ADDENDUM #01

TENDER NUMBER: 634-CP1914

Roof Replacement Project

St. Joseph Catholic School

ENLARGED ROOF PLAN - ROOF PENETRATION AND DIMENSIONS

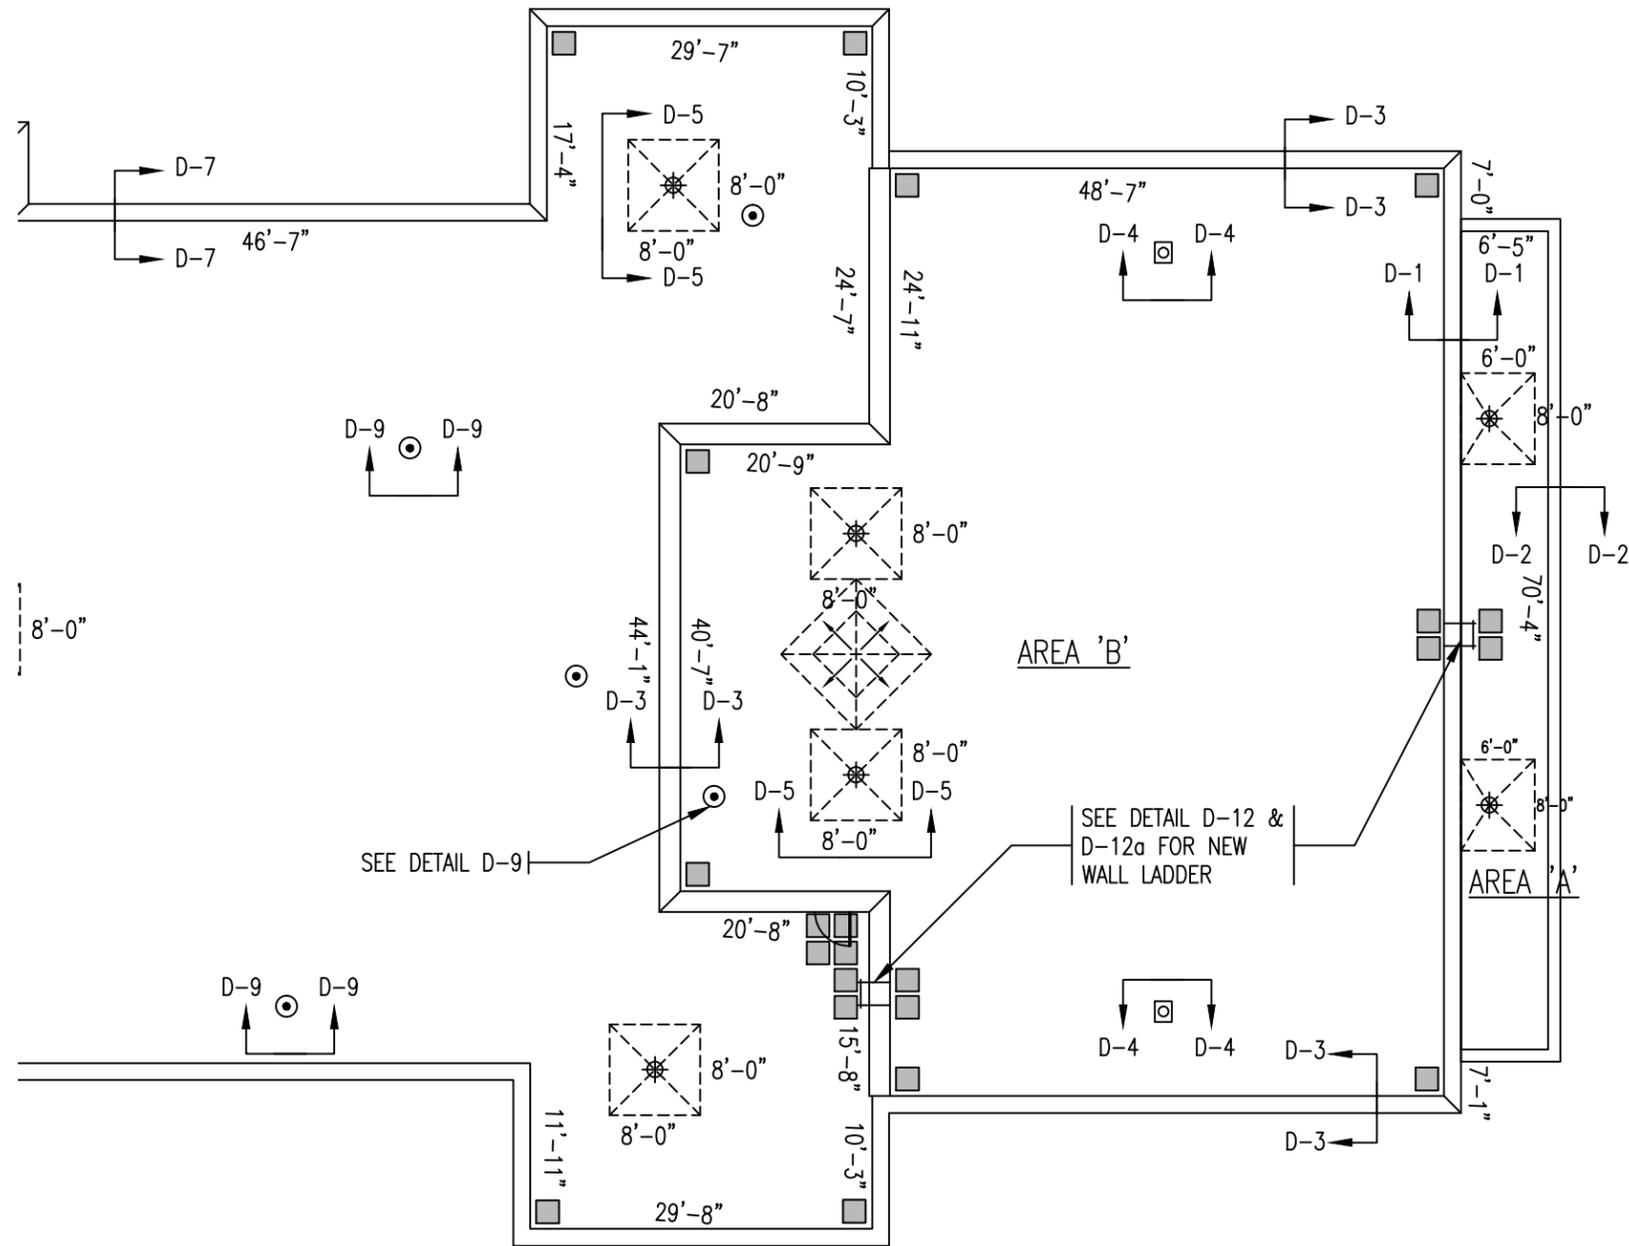
A7. DRAWING R2 is enclosed with this addendum.

Q4: Is the canopy south side of the building considered roof area A? and the adjacent roof being roof area B?

Answer: Drawing R2 clarifies what is considered to be areas A and B.
